PARTS & SERVICE NEWS

REF NO.	AA02106
DATE	April 15, 2002

SUBJECT: TRANSMISSION FILTER MOUNTING BRACKET

PURPOSE: Introduce to the field new transmission filter mounting bracket (EJ9767).

FIGURE 1. MOUNTING BRACKET (EJ9767)

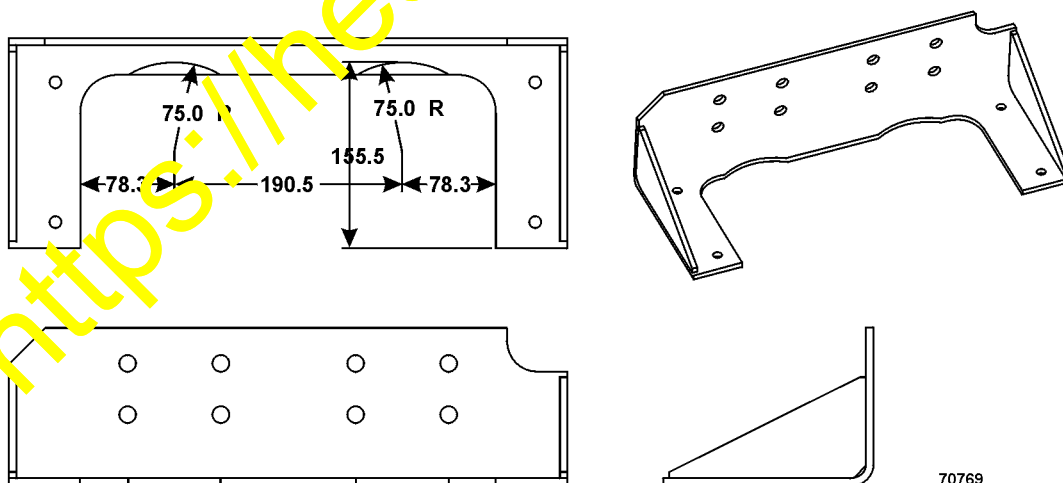
Some trucks in the field may be equipped with transmission filter mounting brackets that interfere with the mounting of the filter canisters. The result of this interference may lead to premature failure of the filter, as well as, breakage of the filter mounting head.

A new filter mounting bracket (EJ9767) has been manufactured with greater tolerances for mounting of the filter canisters. The new bracket replaces the previous bracket (EH8754).

Existing brackets may be modified to the specifications shown in Figure 1.
